1990 - 1991 Corvette: Service Bulletin: Intermittent Electrical Conditions - Repair/Diagnosis Procedures

Model and Year: 1990-91 CORVETTE

Bulletin Number: 91-337-6D - (05/30/1991)

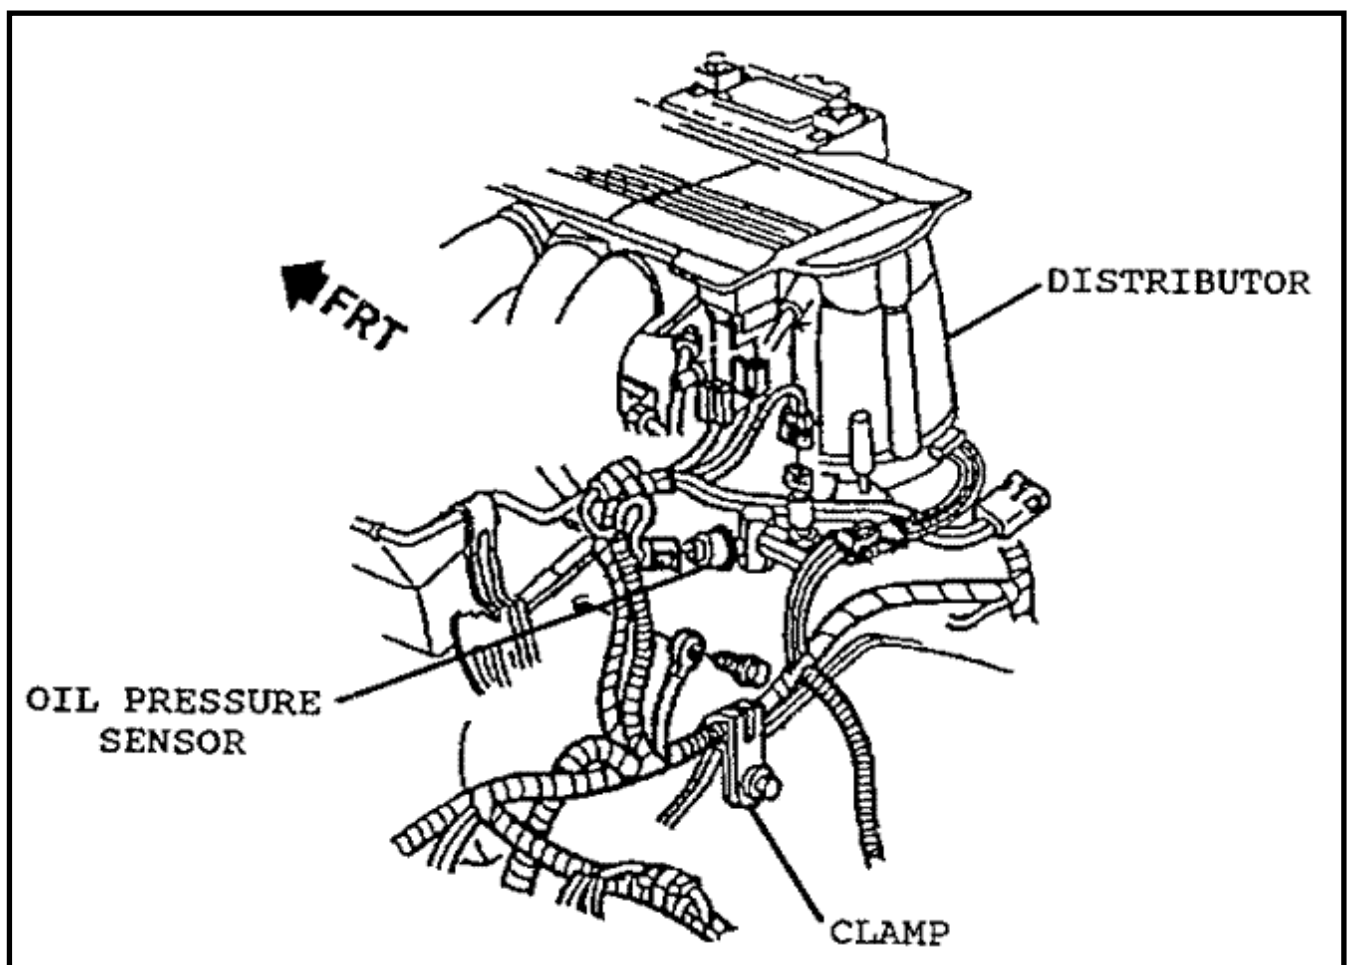
The engine electrical harness may be rubbed thru by the mounting clamp just below the oil pressure sensor (see illustration). The conduit covering the harness may be positioned so that the tab on the clamp can enter the harness thru the slit, allowing the clamp to contact the wires, which are then rubbed thru with the normal movement of the engine.

1. Disconnect negative battery cable.
2. Remove windshield wiper motor.
3. Remove harness from clamp. Carefully inspect the wires for rub thru spots,

and correct the damage as necessary.

4. Wrap the harness with electrical tape. Replace the conduit, then overwrap the outside of the harness with more electrical tape. Secure the harness to the clamp so that the tab cannot enter the harness.
